G.O. No. 738

Amaravati Stupa - Gundur Dt.

Proposed repairs to the Amaravati Stupa in the Guntur District.

Revised Proposals concerning the preservation
of the Amarāvati Stupa, Guntur District.

of Map
of
TRIPTIG PUTHUGUNTUR DISTRICT

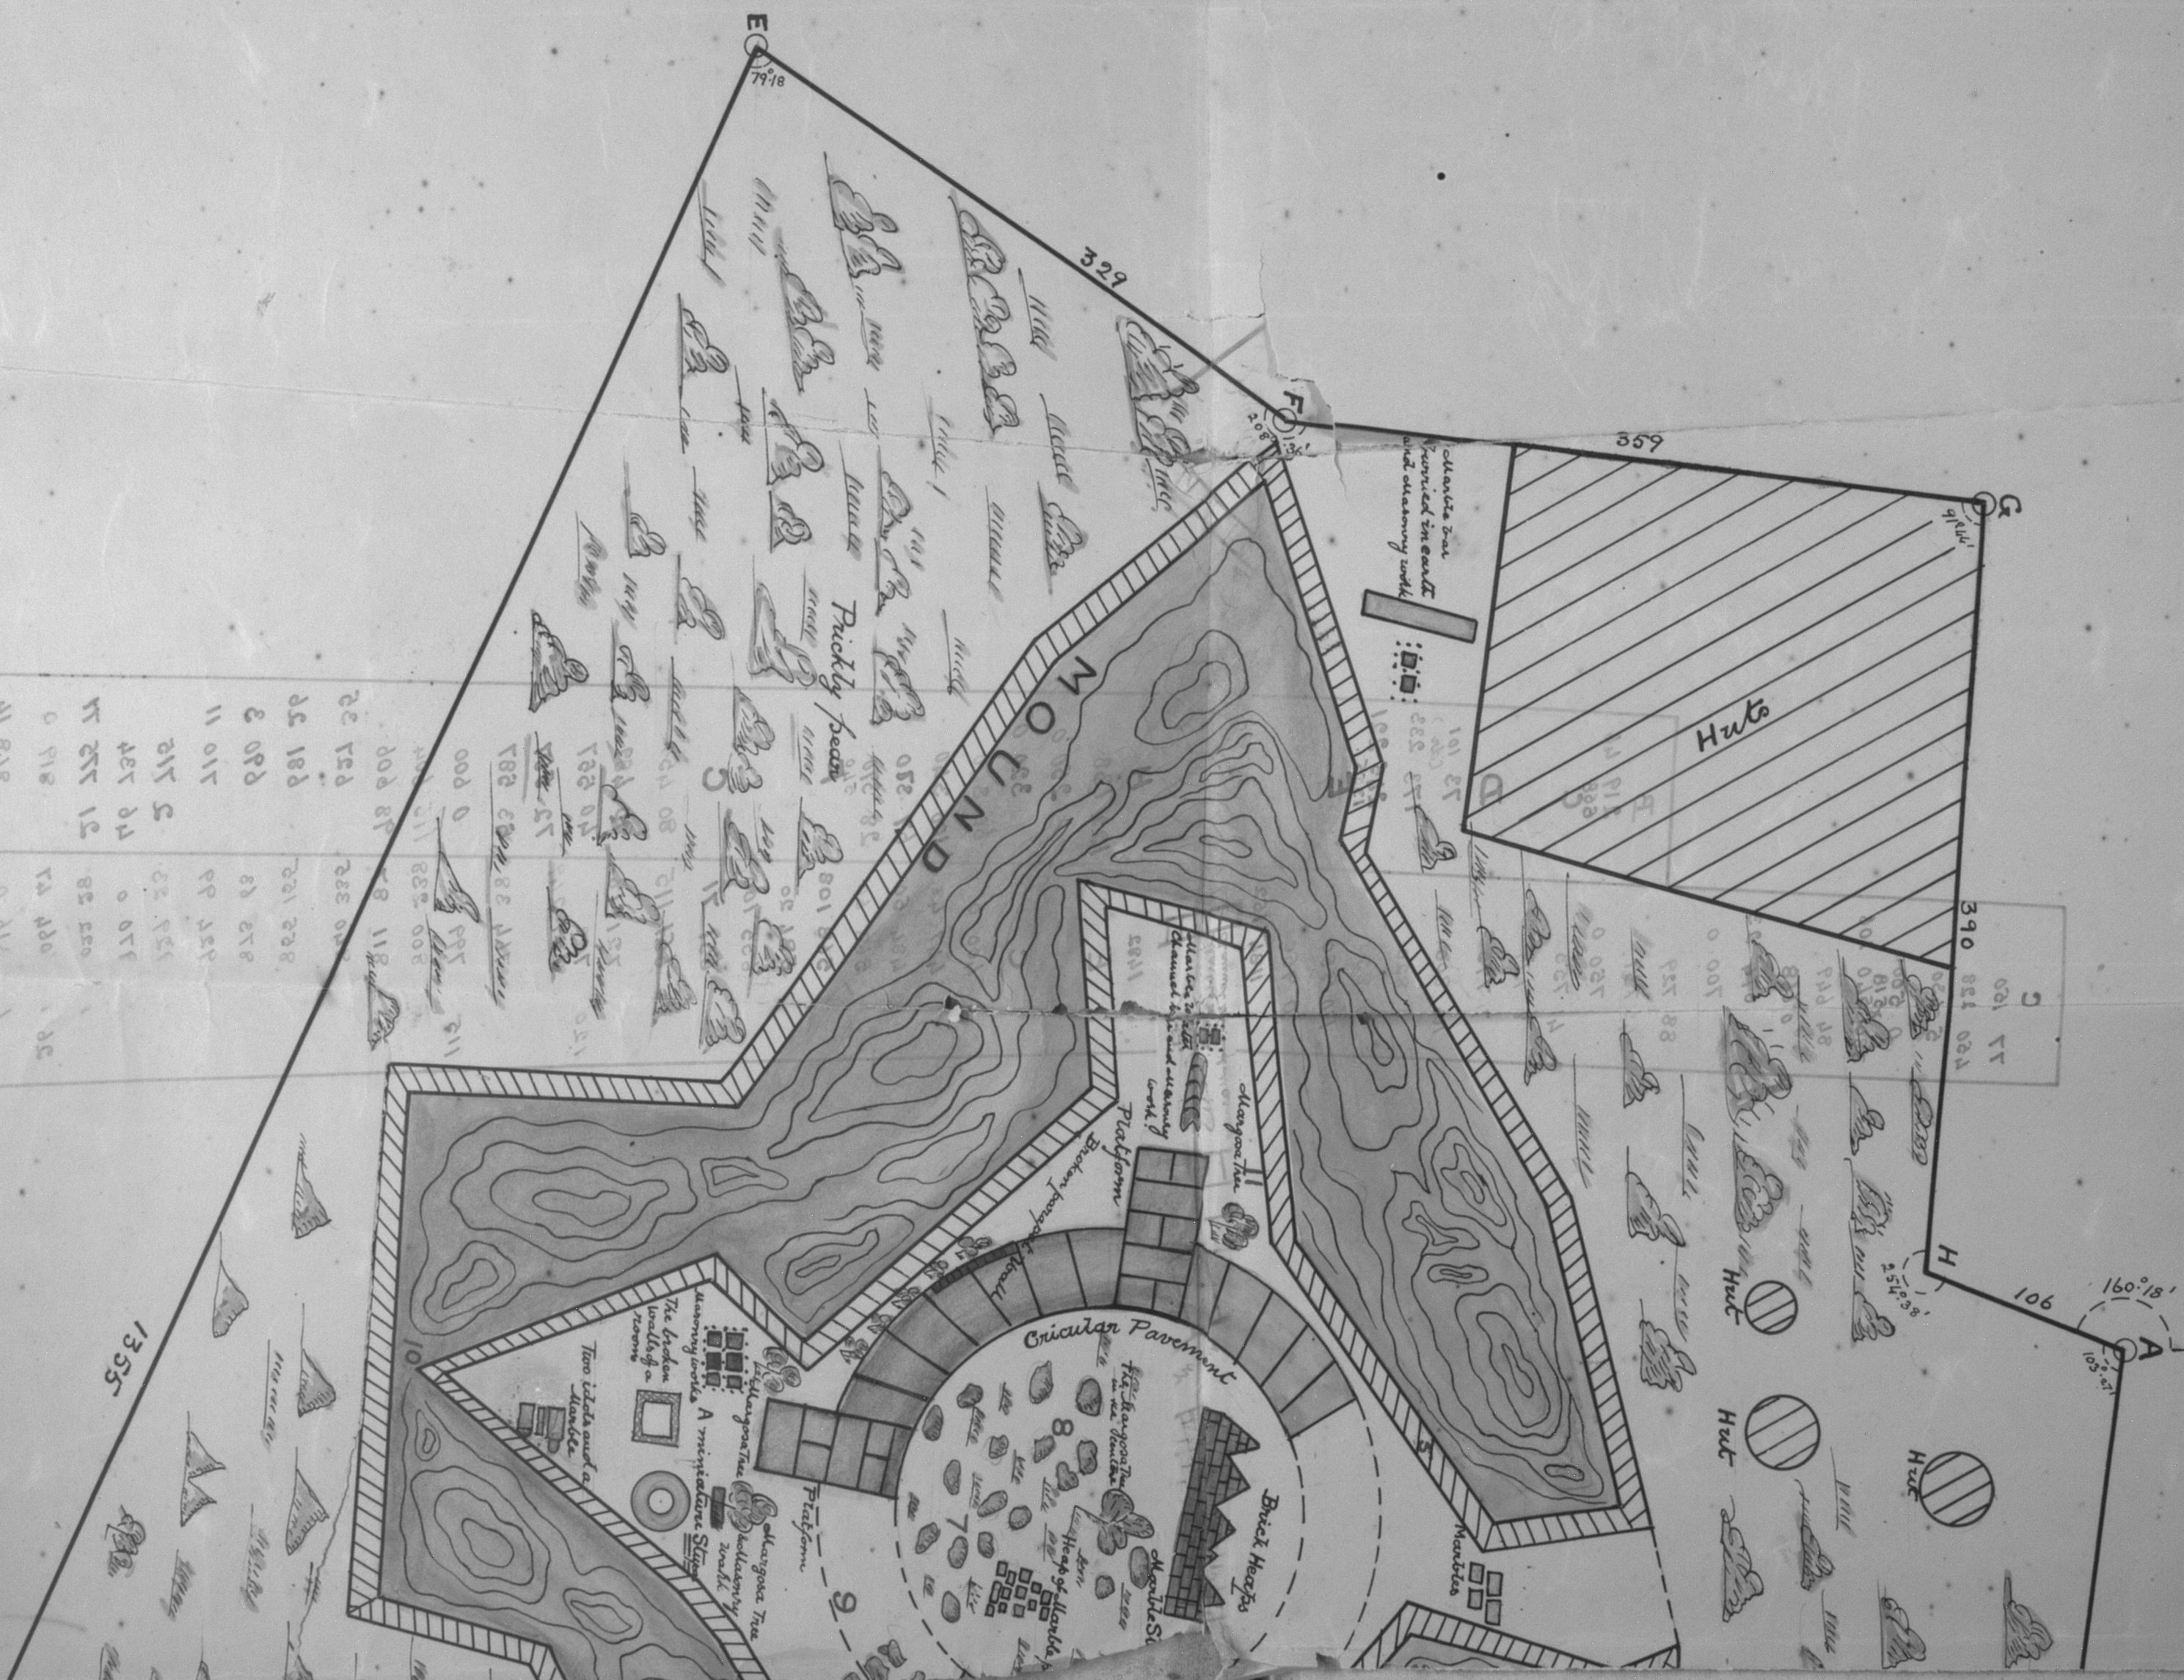
My own suggestion would be to build a wall round
the whole area A B C D E F G H in the enclosed plan, -
spreading the cost over several years. Mr. Longhurst's -
statement that the site of Amaravati occupies an area of

30
several square miles and is occupied chiefly by the -
present village is of course an exaggeration. So far -
as Amaravati refers ^{mainly} to the Buddhist remains, these stand
on a rise well to the westward of the main village --
(the modern Amaravati). To the North of this rise are
two small hamlets. So far as these two hamlets stand on
any part of the site which it might be desirable to -
protect at once, from enquiries made on the spot I do
not think it would be either difficult or ~~expensive~~ ^{expensive} to
give the sites up provided other sites were given else-
where. And this should be done. Concurrently with the
~~Construction of the Enclosure~~ ^{Construction of the Enclosure}, the scrub (calotropis and -
prickly pear) which disfigures the whole site should be
removed. The excavations made in the past should be
filled in. And more trees should be planted. By this -
means a pleasing and well ~~cared~~ ^{care}-for appearance can be -
